ADDENDUM TO COMMISSION PACKET FOR

Item No. W 7a A-4-OXN-07-096

Southern California Edison

Subject: STAFF REPORT ADDENDUM for Item W7a

VP2 • Project vige from milapolist of the SCE property • after

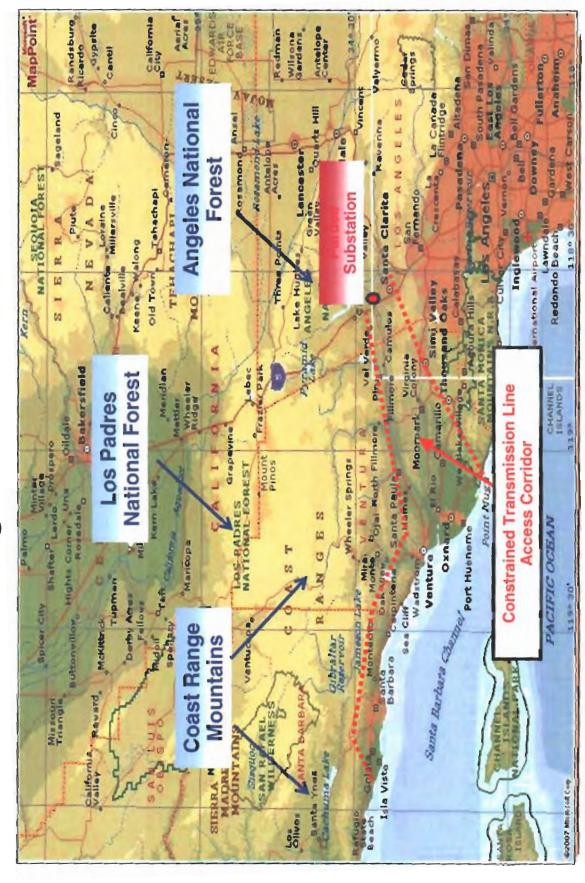
The proposed project 80 foot stack will be visible from many areas along the coast, especially when it is in operation and creates a large vapor plume which was not addressed in the impact analysis. The new stack and plume, when combined with the existing and larger Reliant stack and plume, together will dominate the western horizon of the entire county. This cumulative impact was not addressed and is considered significant by the City. Special Condition 6 removes the screening trees that the City had requested along Harbor Boulevard to screen the peaker plant from the 292-unit Northshore residential development immediately to the southeast of the project site. This is another unmitigated negative impact created by the project. A photo simulation of the stacks and plumes is attached (Attachment 5).
